Scanning Tunneling Microscope Electronics

Changes to Schematic

Title Simple Scanning Tunneling Microscope		
Size B	Number	Revision C
Date: 3-Dec-2003	Sheet 1 of 1	
File:	C:\Documents and Settings\John Alexander\My Documents\MyDesign.ddb

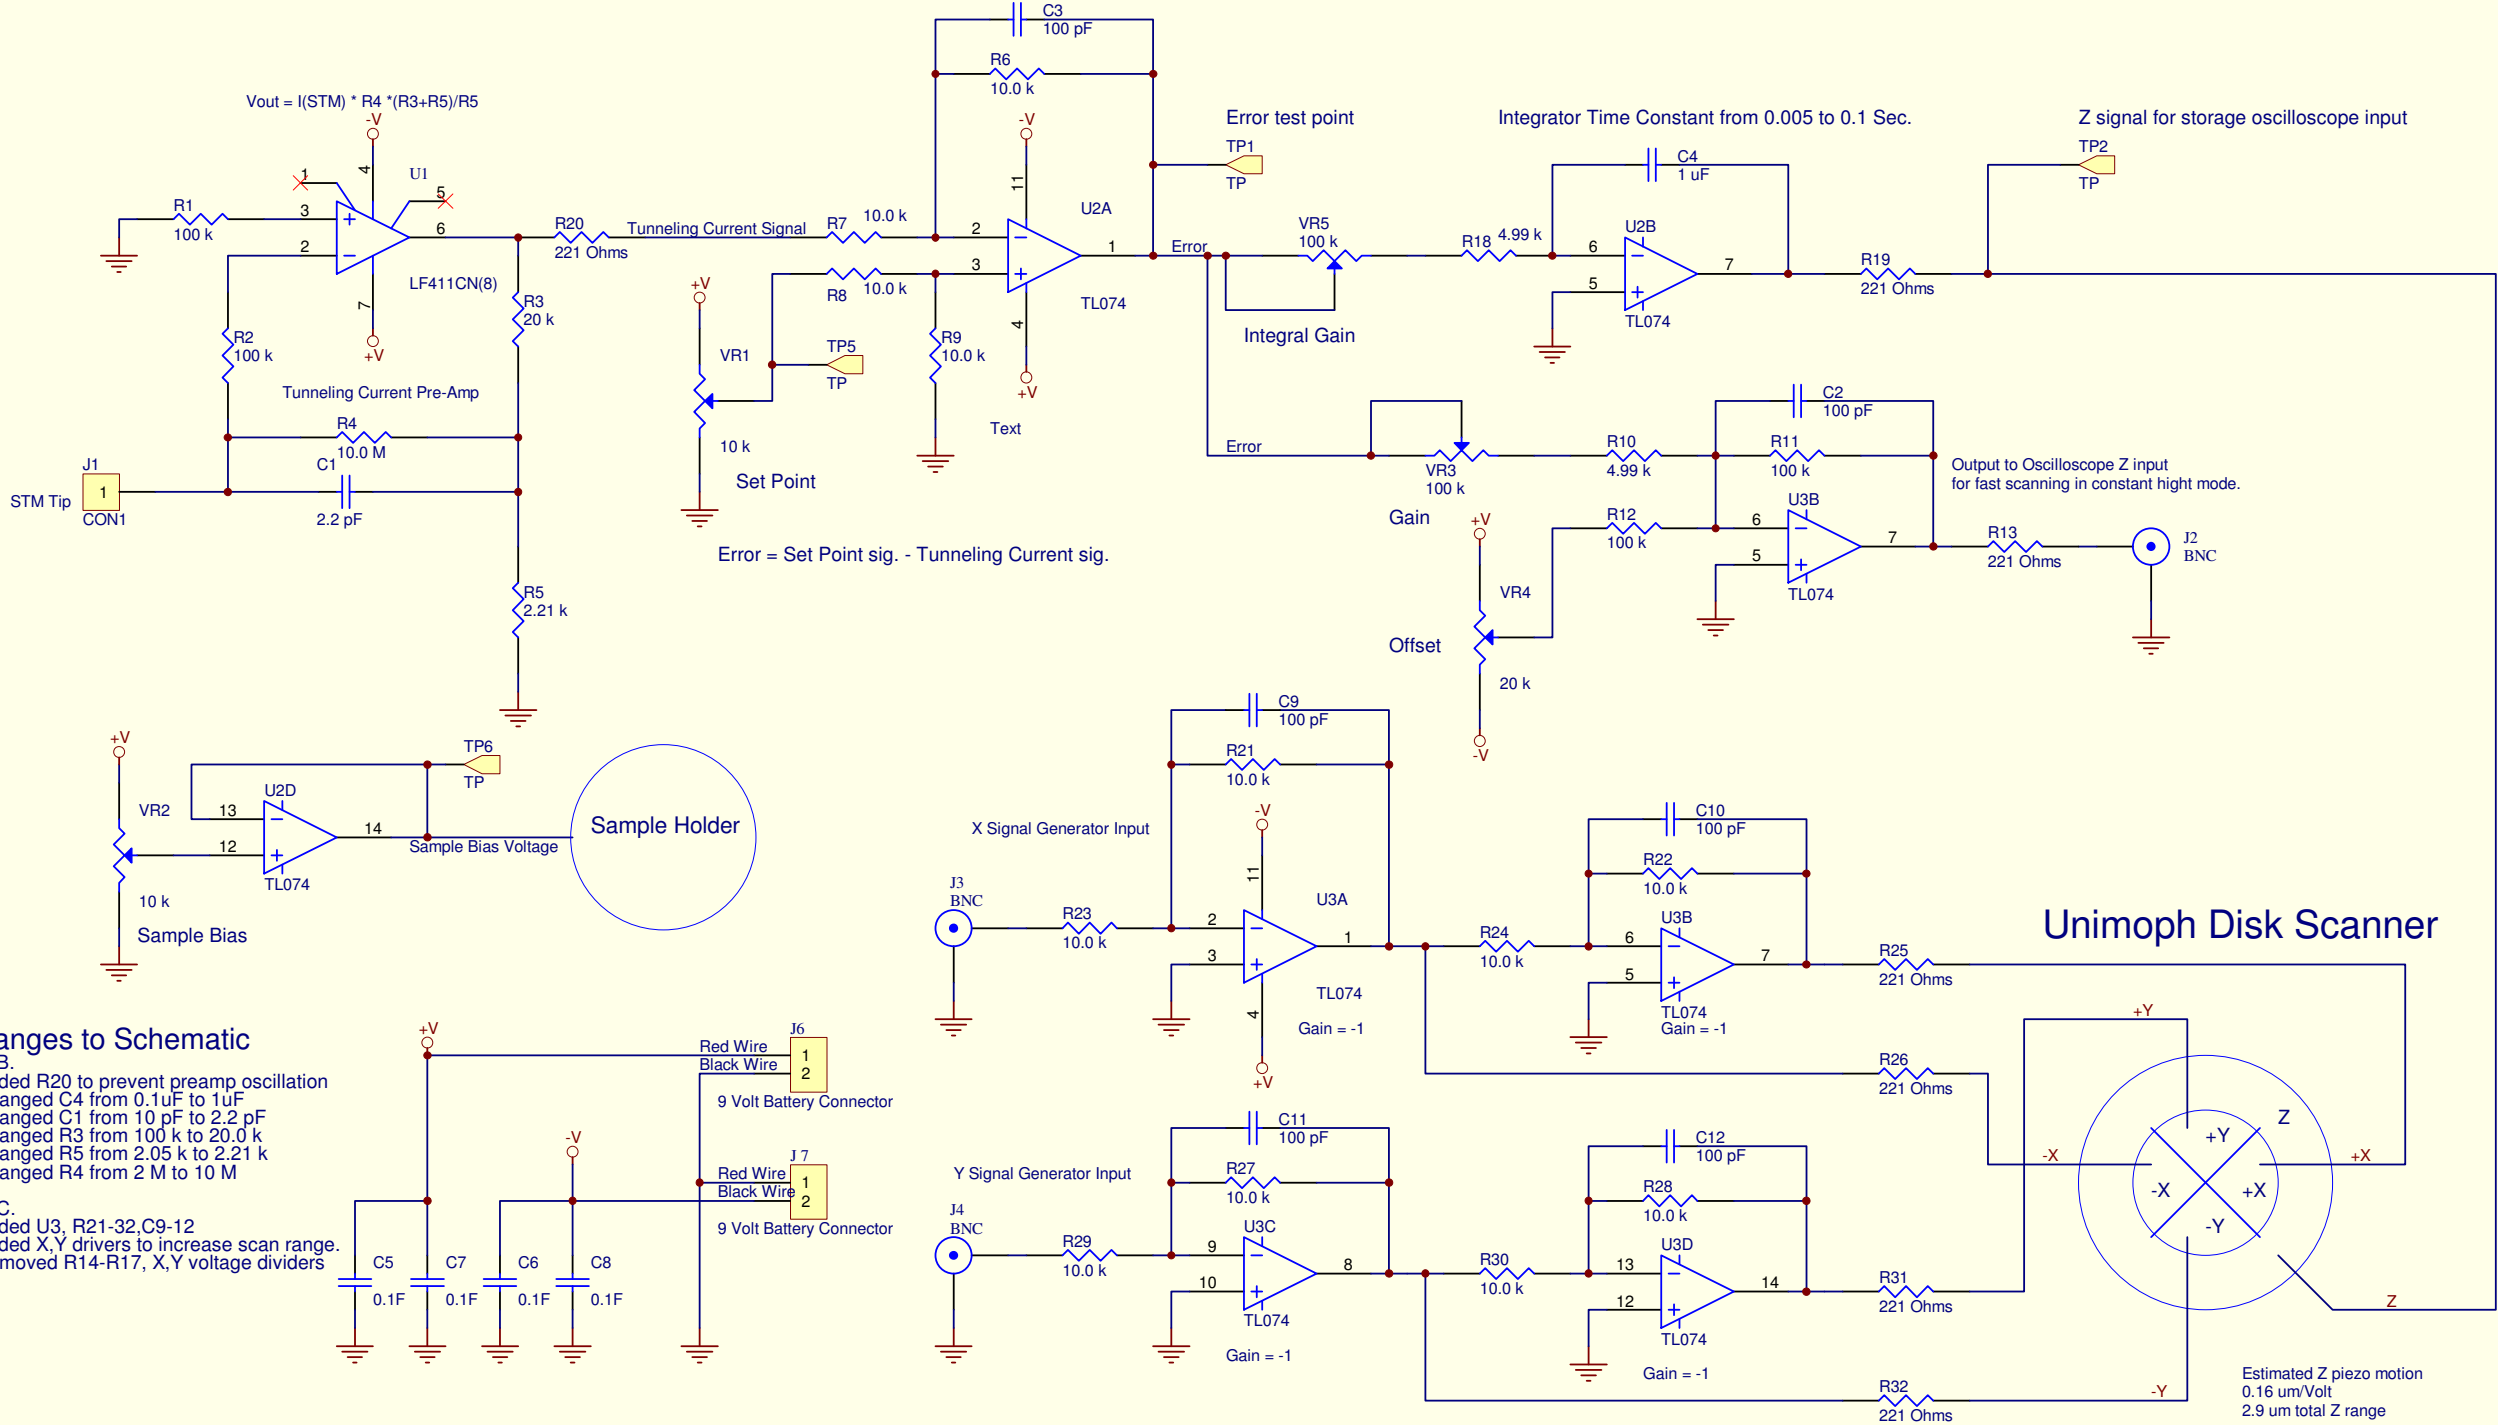
Rev B.
Added R20 to prevent preamp oscillation
Changed C4 from 0.1uF to 1uF
Changed C1 from 10 pF to 2.2 pF
Changed R3 from 100 k to 20.0 k
Changed R5 from 2.05 k to 2.21 k
Changed R4 from 2 M to 10 M

Rev C.
Added U3, R21-32, C9-12
Added X,Y drivers to increase scan range.
Removed R14-R17, X,Y voltage dividers
